APPLICATION BY NNB GENERATION COMPANY (SZC) LIMITED FOR AN ORDER GRANTING
DEVELOPMENT CONSENT FOR THE SIZEWELL C PROJECT

AMENDMENT TO THE APPLICATION AND INCLUSION OF ADDITIONAL LAND

Submission to Planning Inspectorate on behalf of Suffolk Building Preservation Trust concerning the impact of proposals regarding Pakenham Fen and the operation of the historic Pakenham Water Mill. Updated 1 October 2021.

Figure 1 Proposed development of Fen Meadows

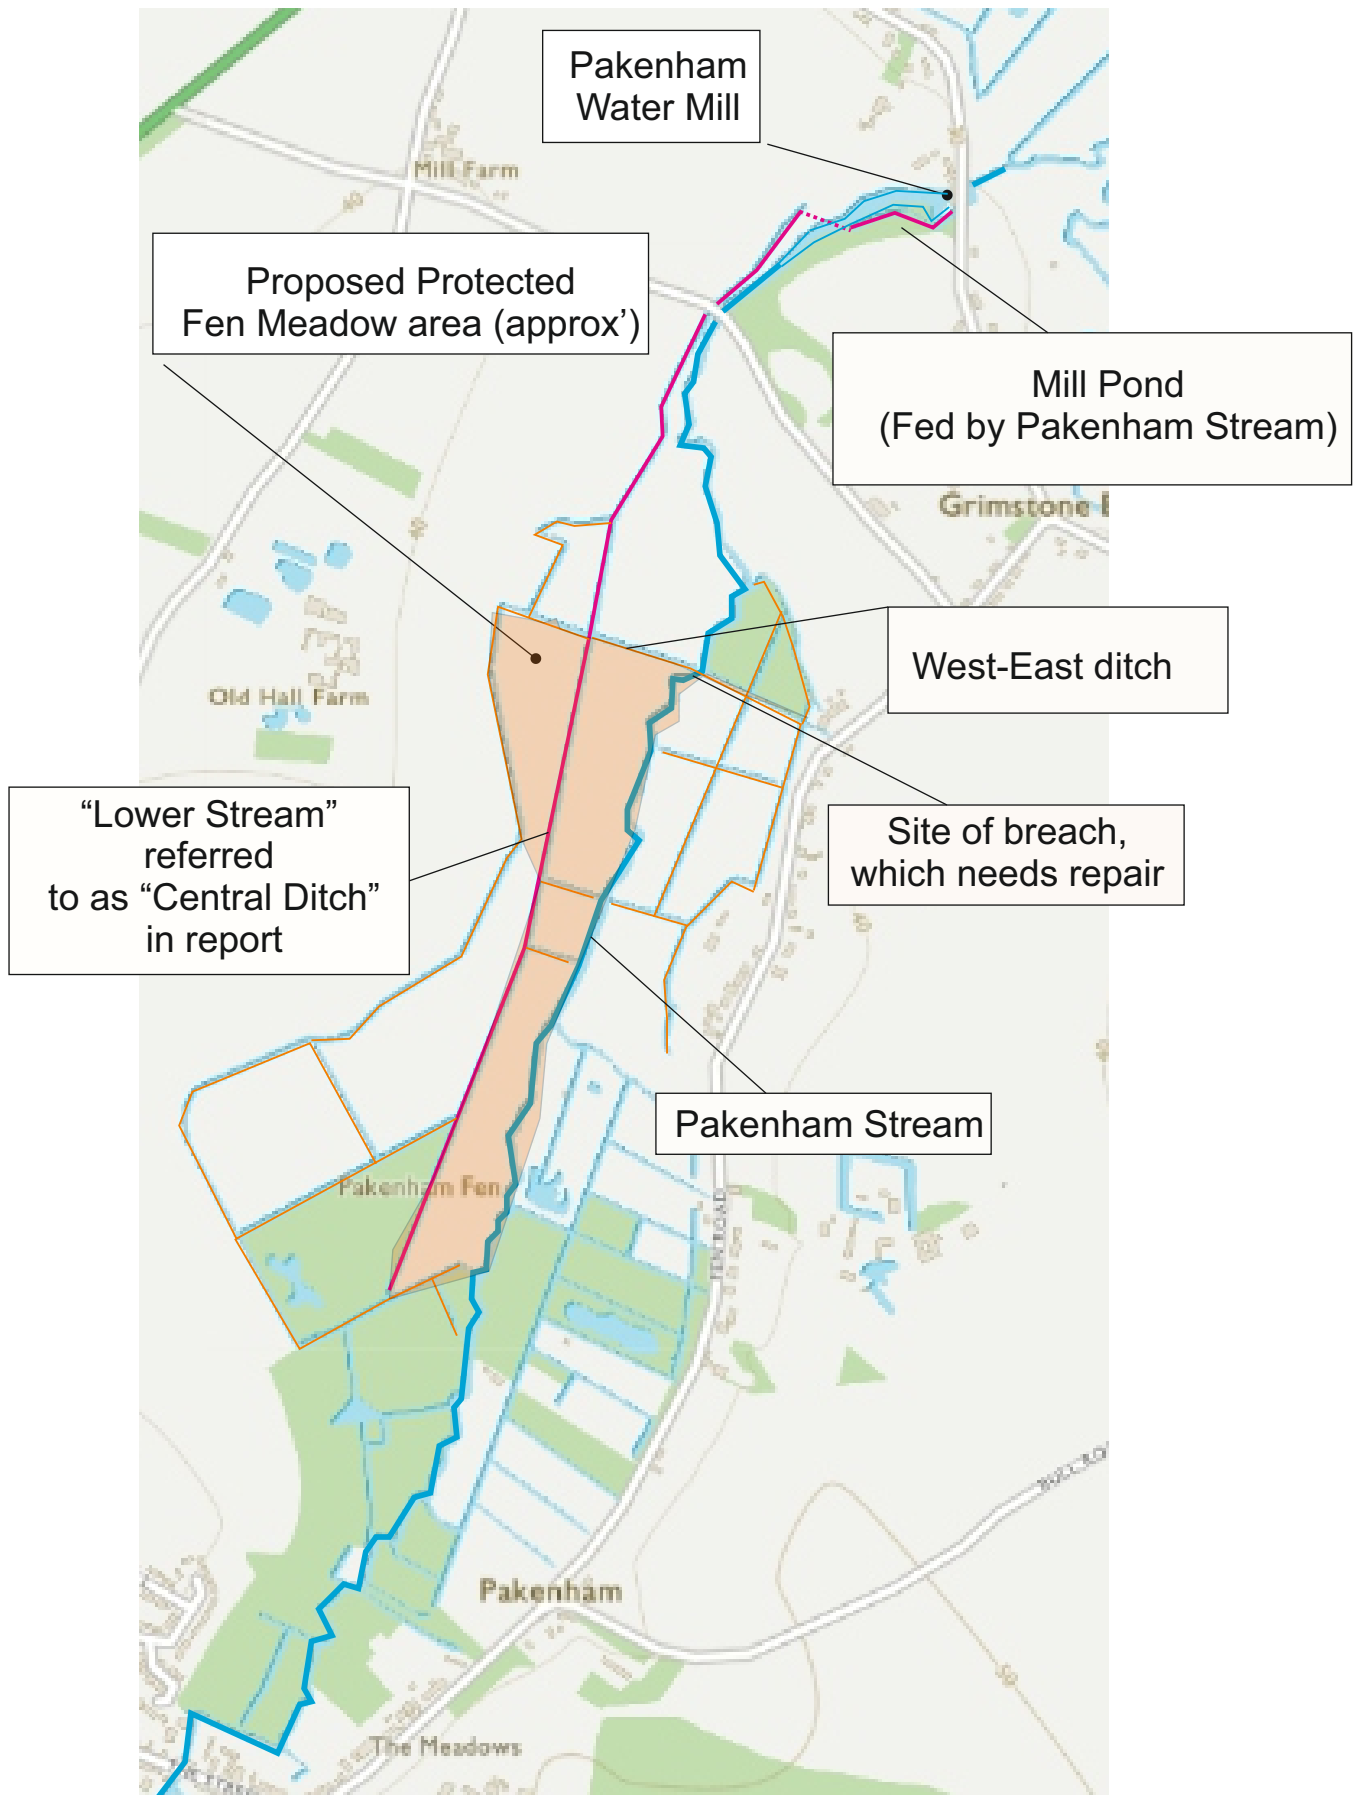
7. The scope of the monitoring and investigation work by Woods as detailed in Report 9.64 has not extended as far north as Pakenham Mill (Figure 1) and no baseline flow monitoring has been established at Pakenham Mill, despite the offer from Suffolk Building Preservation Trust to provide full support and assistance in this regard.

9. Site work by Woods has identified a breach in the Pakenham Stream bank where a west-east ditch crosses over the stream, referred to in Paragraph 4.3.7 in Report 9.64 (Figure 1). The report identifies that the flow in the Central Ditch is being supported by flow from Pakenham Stream via this breach.

10. Report 9.64 proposes that that the surface level between the Central Ditch and Pakenham Stream in the Northern area will be lowered. There has been no assessment of how this will impact flow rates in Pakenham Stream, and therefore influence Pakenham Mill which lies downstream of this area.

11. Report 9.64 notes at section 4.5.8 that the “leak” from Pakenham Stream supports the ditch water levels on the proposed site and therefore should be retained. However, the report does not mention that this breach is due to poor maintenance of the riverbanks by the riparian owner, and is not a naturally occurring feature. Therefore, it cannot be relied on as a source of water to the Central Ditch and must be repaired.

Figure 1 Drainage System & Source of Water

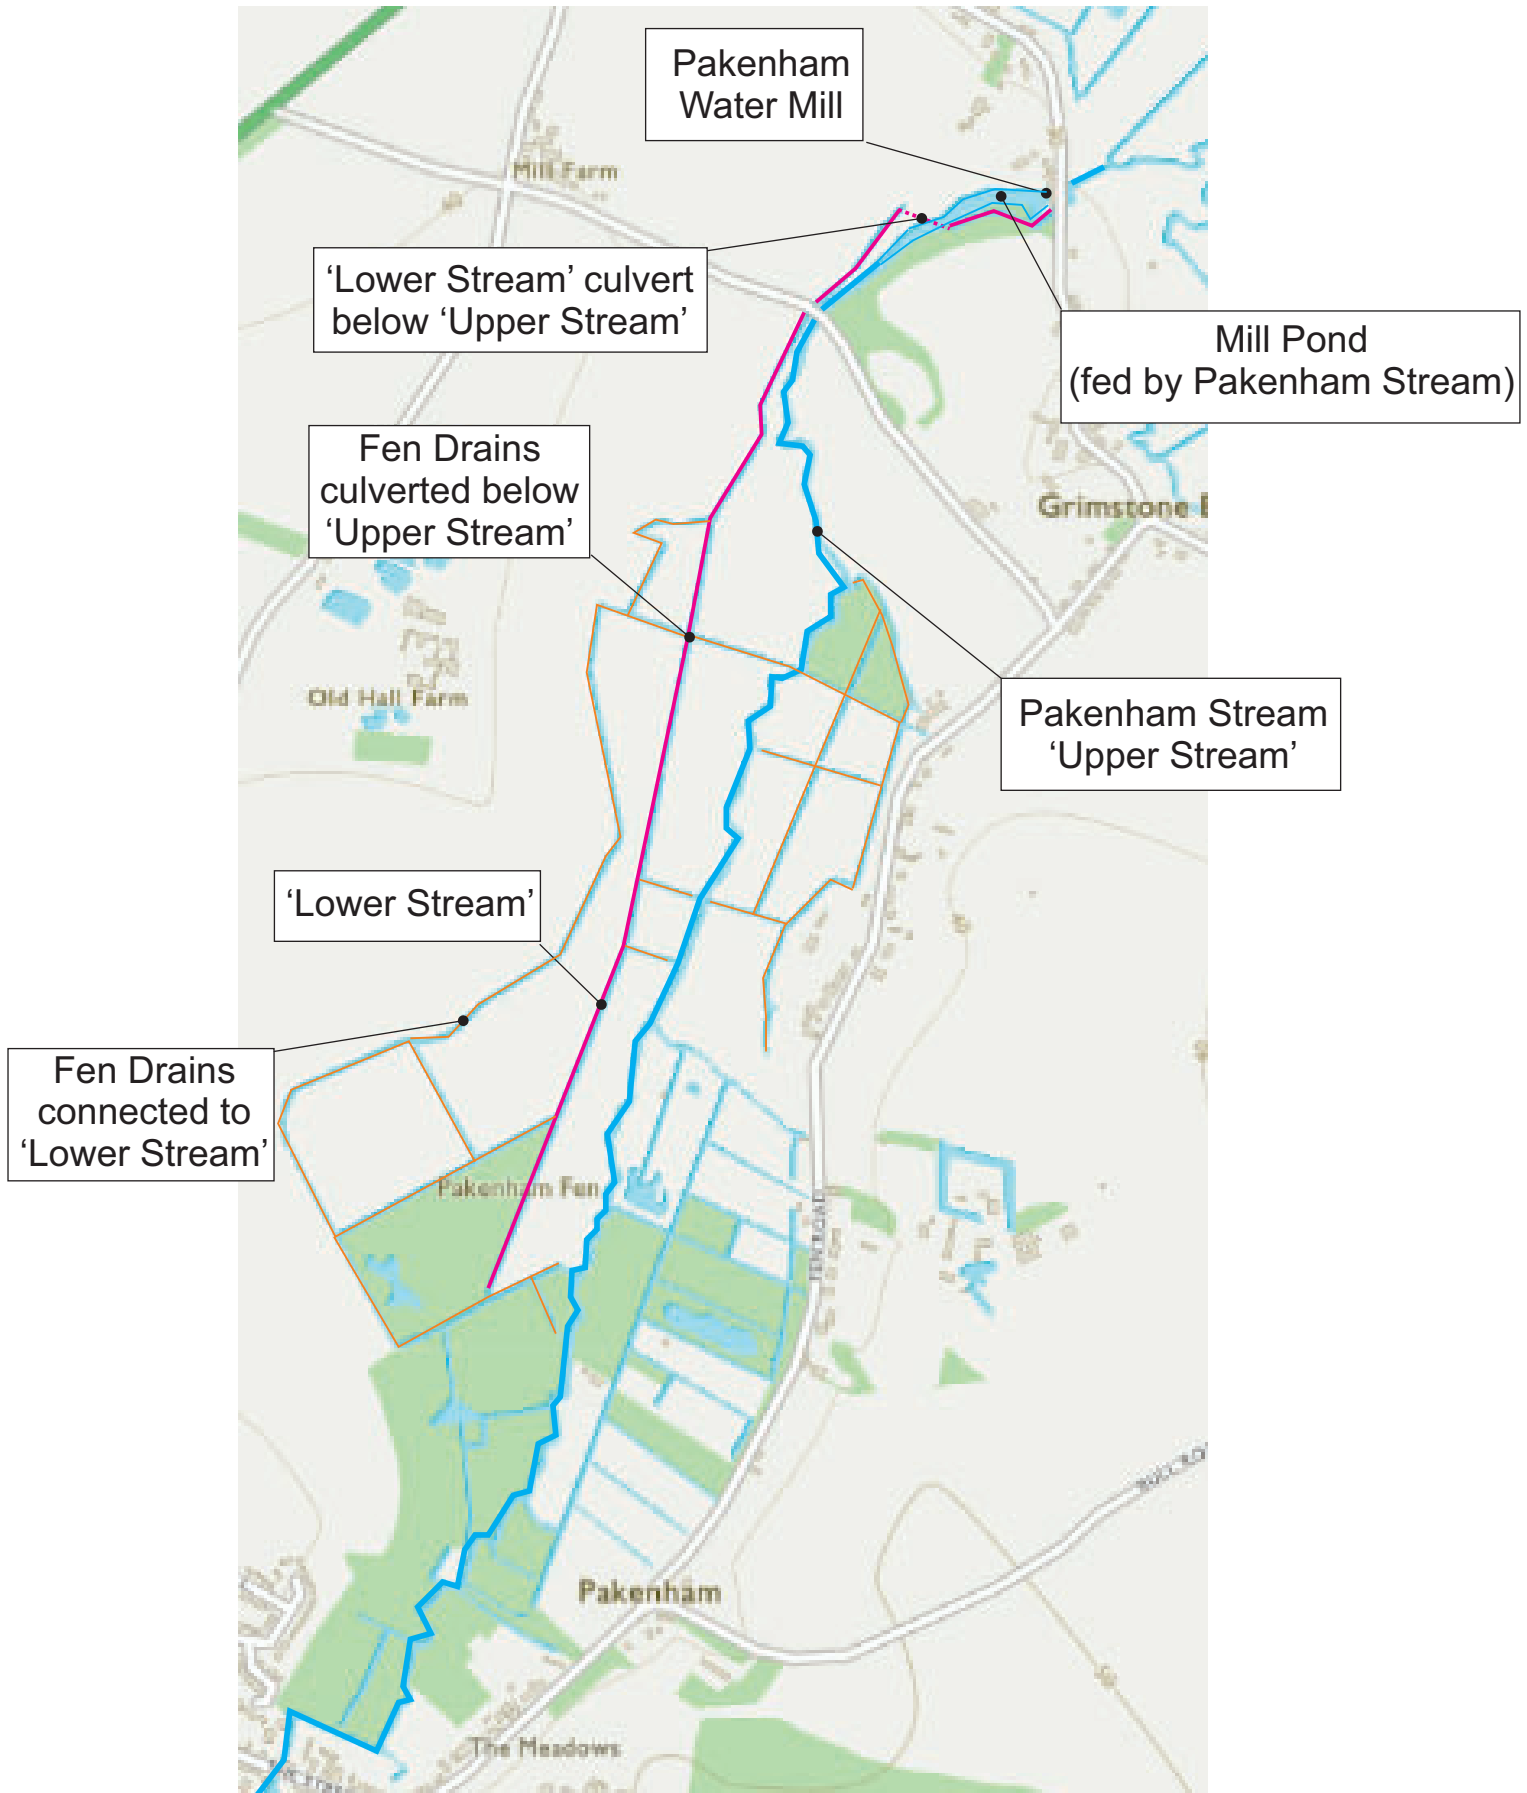
5. The mill pond is fed by the Pakenham Stream (Figure 1), the catchment for which extends over c. 37km² (3747ha).
6. The flow in the stream is maintained by rainfall runoff, as well as groundwater from the shallow and deeper geology. The groundwater flow is critical in sustaining flows through the late spring, summer and early autumn.

9. A series of ditches drain Pakenham Fen, the land to the east of Pakenham Stream being drained by ditches and culverts **under** the Pakenham Stream. This water leaves the Fen area by the “lower stream” which runs north, parallel to Pakenham Stream and passes in a culvert **underneath** the mill pond (Figure 1). The two streams merge after the mill pond sluice on their way to Mickle Mere where they join the Blackborne River. There should be no connection between the upper and lower streams. Only through poor maintenance of the riverbanks by riparian owners will water be lost from Pakenham Stream to the “lower stream”.

Figure 2 Proposed Area of Protected Fen Meadow

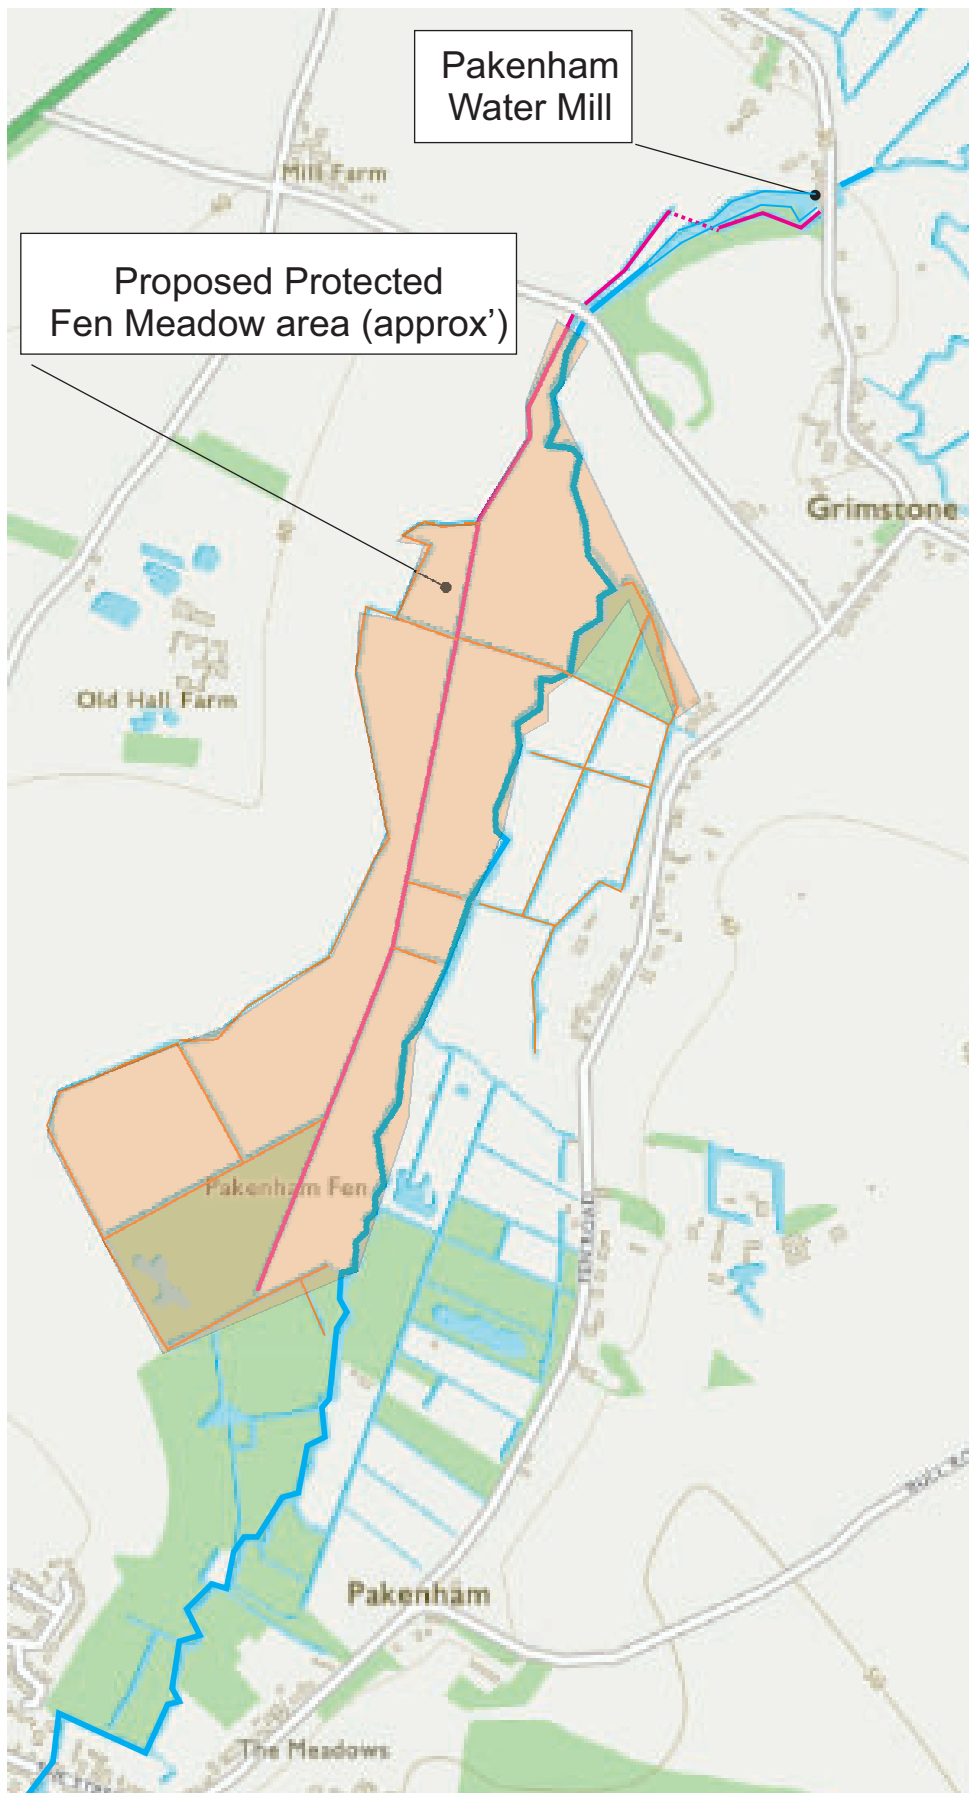
11. The proposed area for the fen meadow development is shown running along the boundary of Pakenham Stream (Figure 2), which feeds the mill pond. Any alteration to the adjoining land could have an impact on the supply of water to the Mill.
